PROPOSED RETAIL/OFFICE BUILDINGS  
LOT 5A RICHFIELD PARK SUBDIVISION  
4545 ALAMEDA BLVD NE  
ALBUQUERQUE, NEW MEXICO 87113

DRB ADMINISTRATIVE  
SITE PLAN AMENDMENT

PROJECT NO. 1005410  
APPLICATION NO. 12DRB-70062

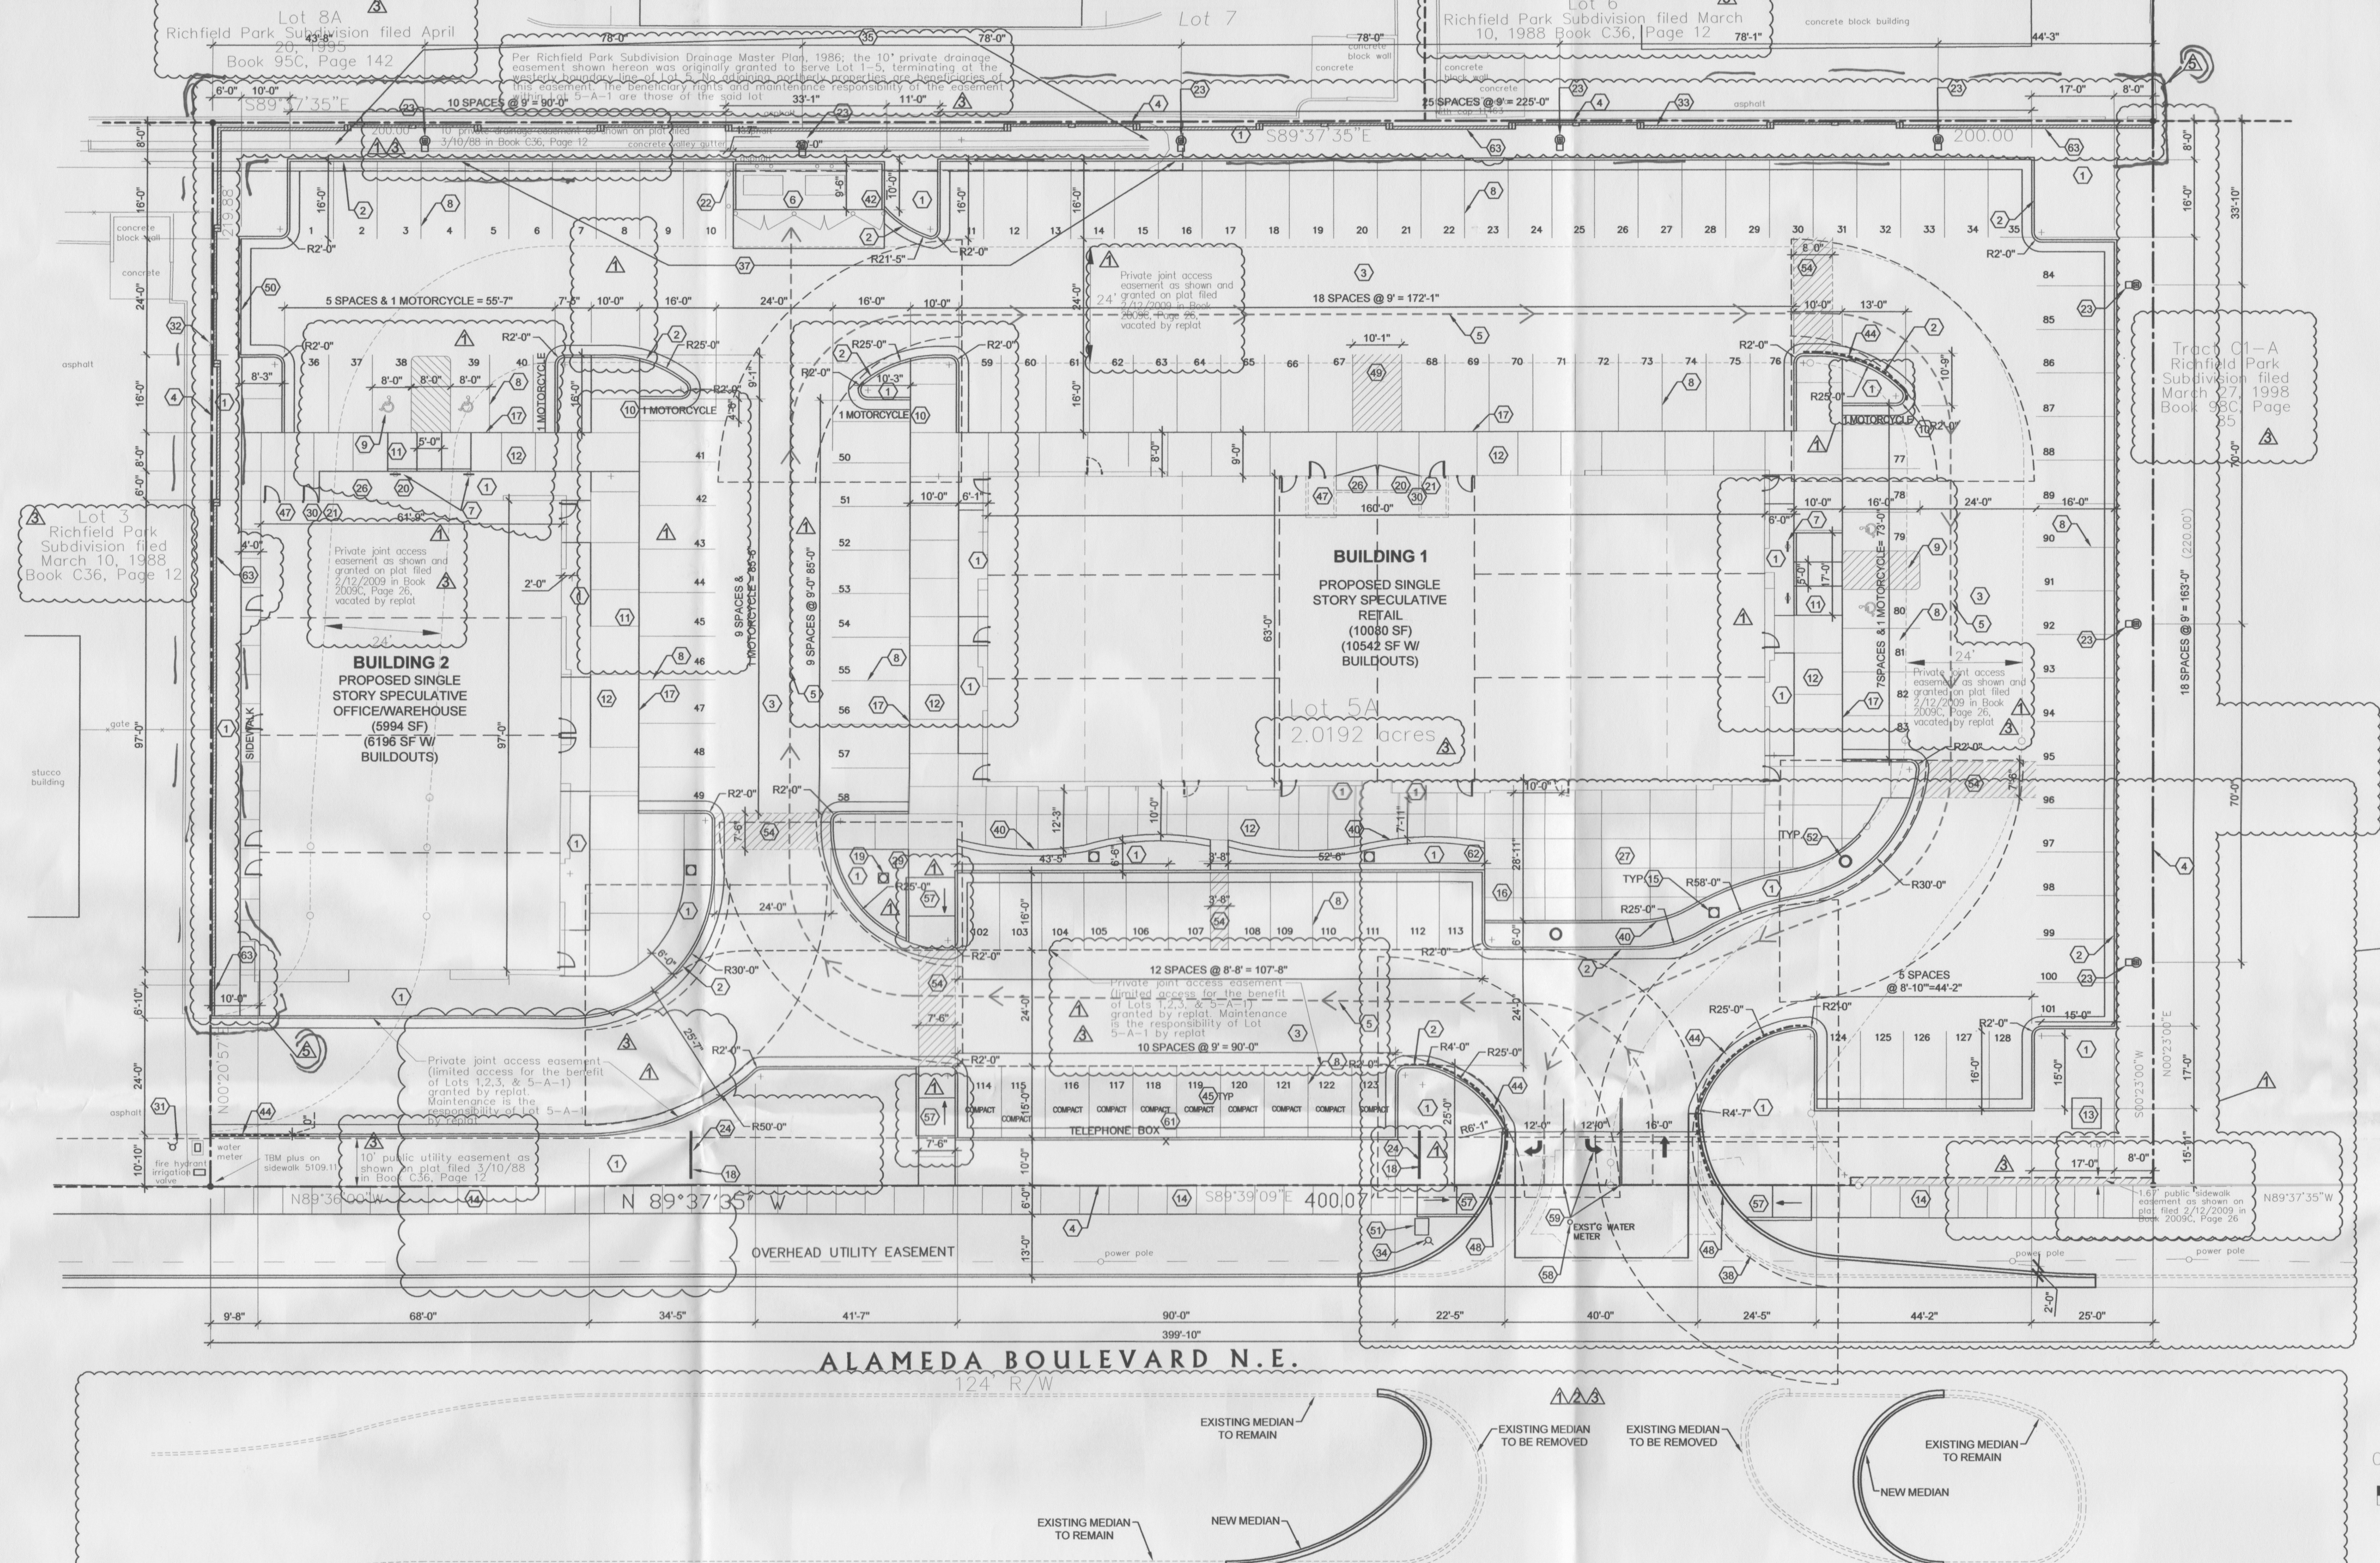
- REVISIONS:
- 4-3-12 DRB 3-21-12 COMMENTS & EASEMENT REVISIONS
  - 5-11-12 ENTRY DRIVE RELOCATION & ASSOCIATED REVISIONS
  - 6-13-12 MEDIAN CLARIFICATIONS, DRAINAGE EASEMENT MAINTENANCE & BENEFICIARIES CLARIFICATION, REPEAT COORDINATION
  - 6-18-12 DRB COMMENTS ZONING & BOLLARD DETAIL
  - 10-16-12 ADMINISTRATIVE AMENDMENT - NEW RETAINING GARDEN WALLS

- NOT USED.
  - RELOCATE EXISTING TELEPHONE BOX.
  - EXTEND LOCKERS FOR BIKE HELMETS, GEAR, ETC.
  - NEW DESERT TAN SPLIT FACE STUCCO CMU RETAINING GARDEN WALL ALONG NORTH AND WEST PROPERTY LINES. SEE RETAINING WALL PERMIT SET SHEETS 1 AND 2. MAXIMUM HEIGHT ON EXTERIOR SIDE OF WALL FROM NEIGHBORING PROPERTY IS 6'-0" EXPOSED ON NORTH SIDE AND 8'-8" ON WEST SIDE.
